II. Corrections and Additions to the Draft EIR

This section of the Final EIR provides changes to the Draft EIR that have been made to revise, clarify, correct, or add to the environmental impact analysis for LACMA Building for the Permanent Collection (the Project). Such changes are a result of public and agency comments received in response to the Draft EIR and/or new information that has become available since publication of the Draft EIR. The changes described in this section do not result in the Project creating any new or substantially increased significant environmental impacts.

The Applicant has proposed several modifications to the Project as described in the Draft EIR, which are primarily related to the design of the Museum Building. Refinements to the Museum Building include: (1) an overall square footage reduction from approximately 387,500 gross square feet to approximately 347,500 gross square feet; (2) a shift of the portion of the Museum Building crossing Wilshire Boulevard approximately 30 feet to the east; (3) a change in the geometry of the Pavilions to the Museum Building from polygonal to rectilinear forms and an alteration to the curvilinear geometry on the e

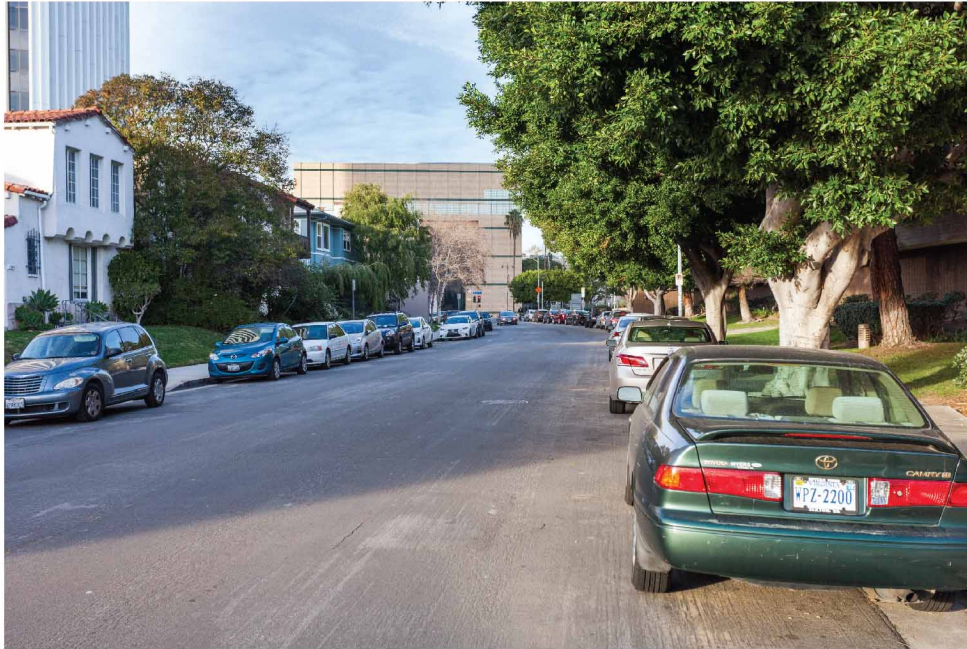
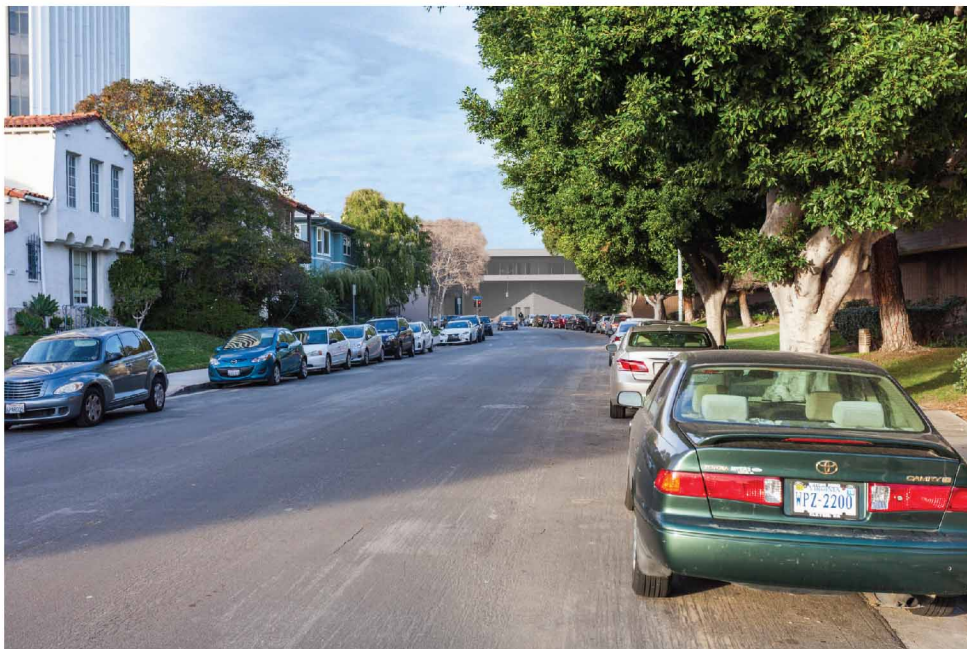
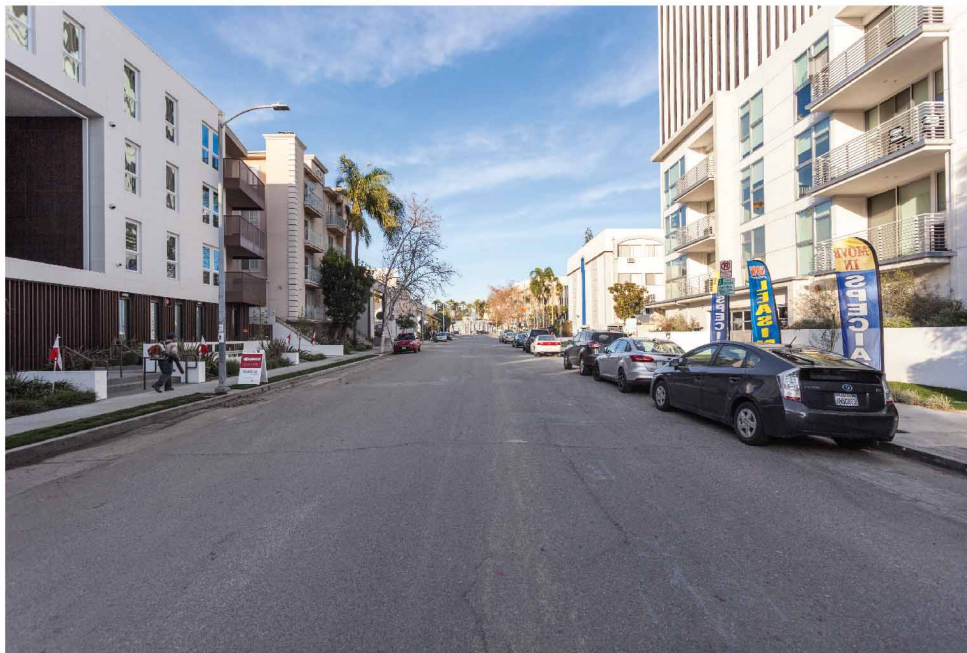
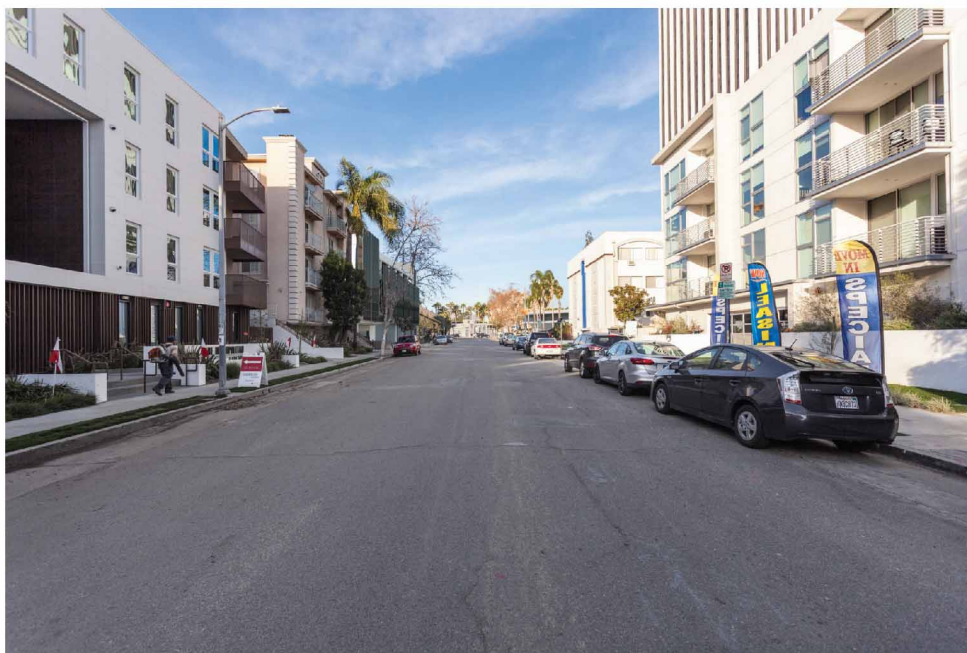
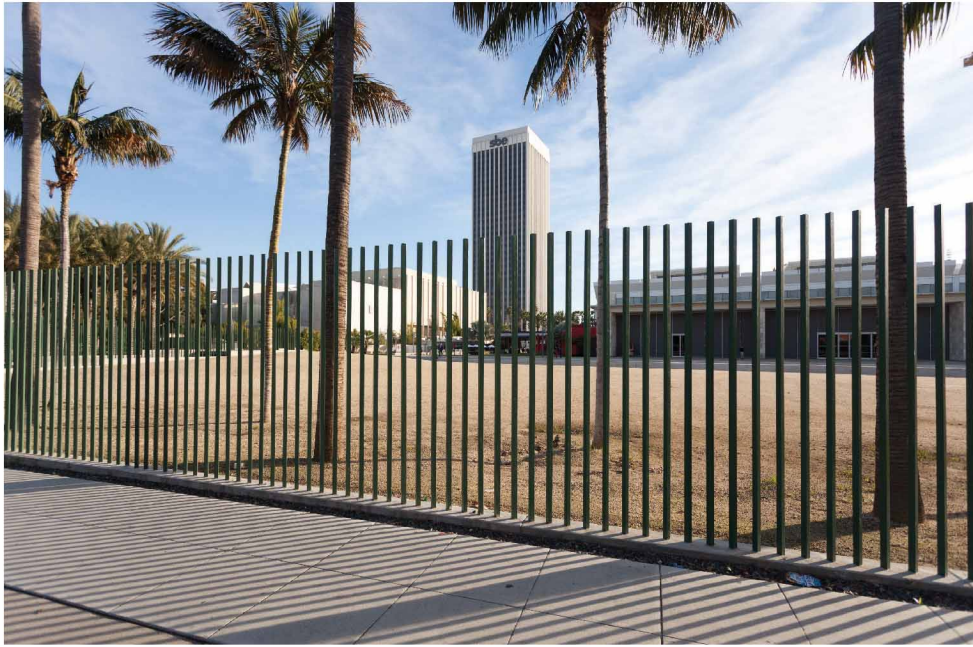
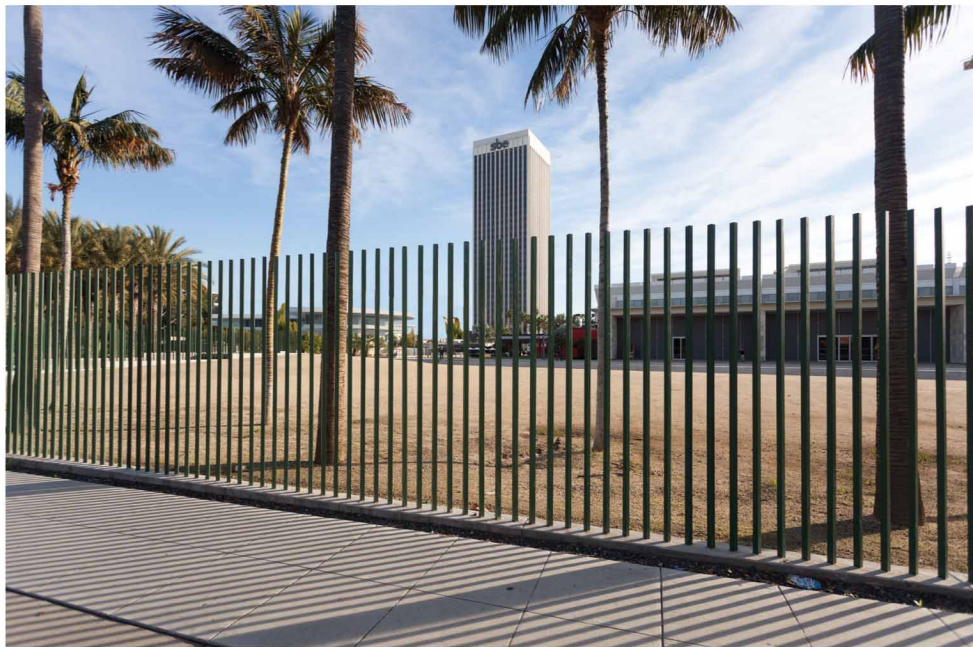
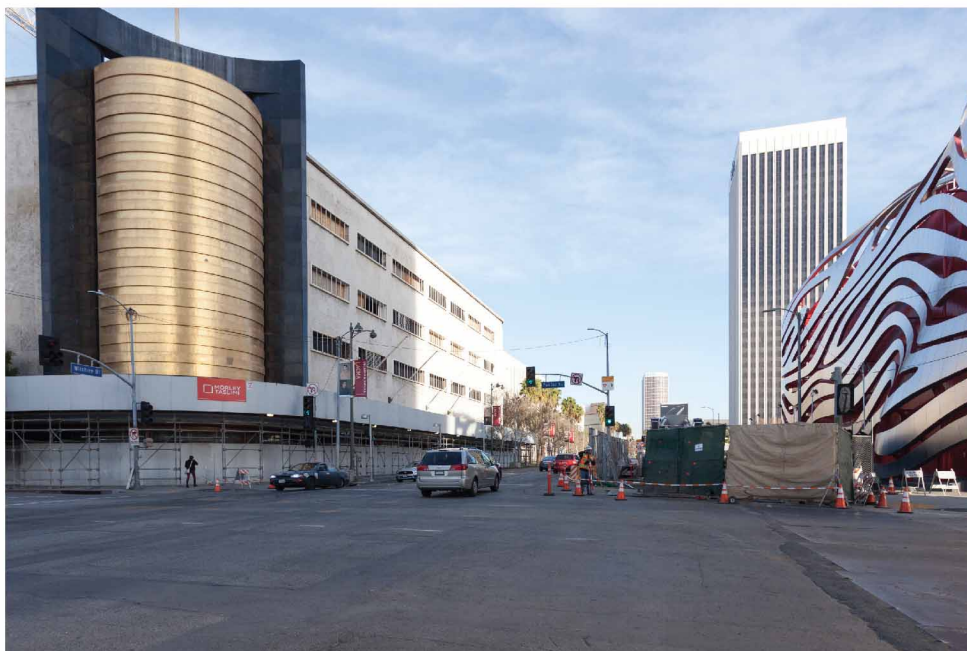
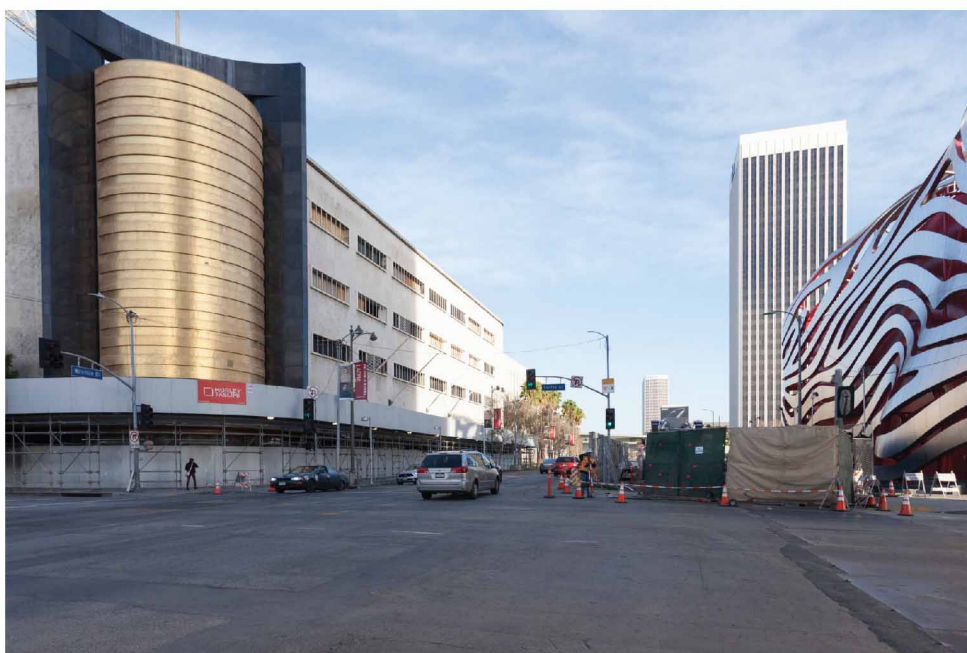
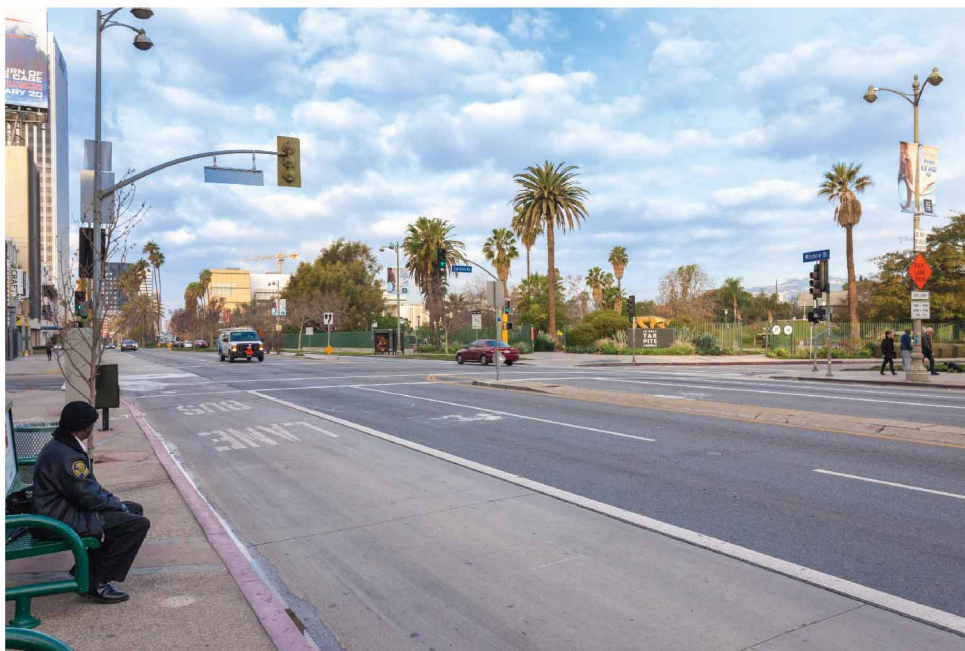
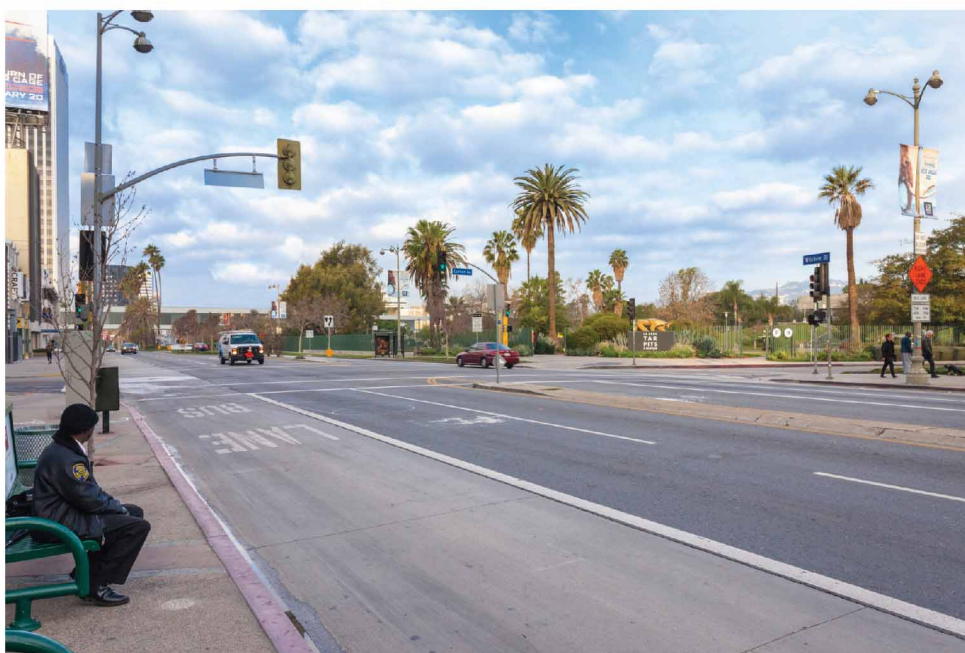
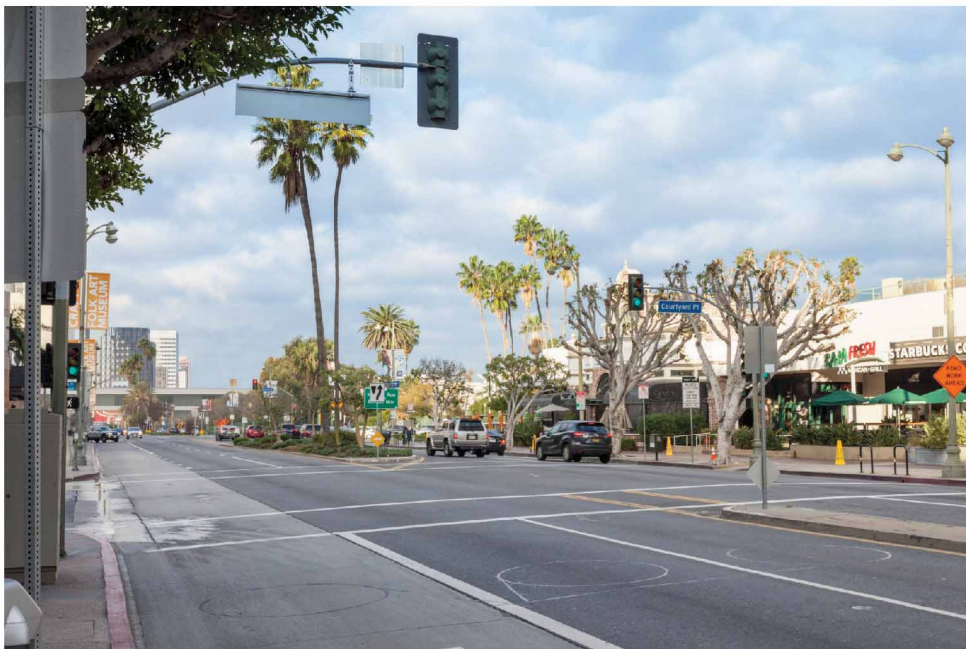
Volume 1, Section IV.A, Aesthetics, Views, Light/Glare, and Shading, pages IV.A-30 through IV.A-38, replace Figures IV.A-4 through IV.A-12 with Revised Figure IV.A-4 through Revised Figure IV.A-12, on pages II-20 through II-28.
